PROJECT: Roof Replacement of
Field House, Maine Maritime Academy
Castine, Maine

SUBJECT: ADDENDUM NO. 3

DATE: December 6, 2018

MAINE MARITIME ACADEMY CASTINE, MAINE		DRAWN BY: WEB
INDEPENDENT ROOF SERVICES POWNAU, MAINE	SCALE: 1"=30'	REVISED BY: JLB
TITLE: EXISTING ROOF PLAN		
DATE: 11-6-18	FILE NAME: MMA	DRAWING #: R1

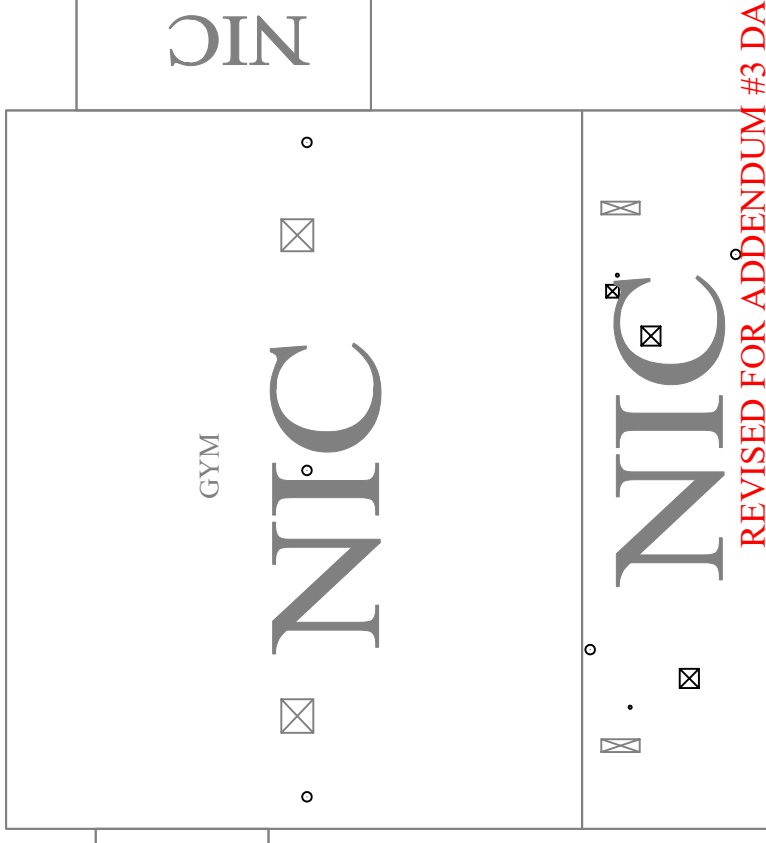
Drawing R1 and R2 have been revised to show an area where 7/16" OSB was used as a cover board and the re-issued drawings no longer show a fan curb that was long ago removed from the roof. Drawing R1 and R2 revised for addendum number 3 are attached hereto.

18'x48' AREA OF OSB COVER BOARD
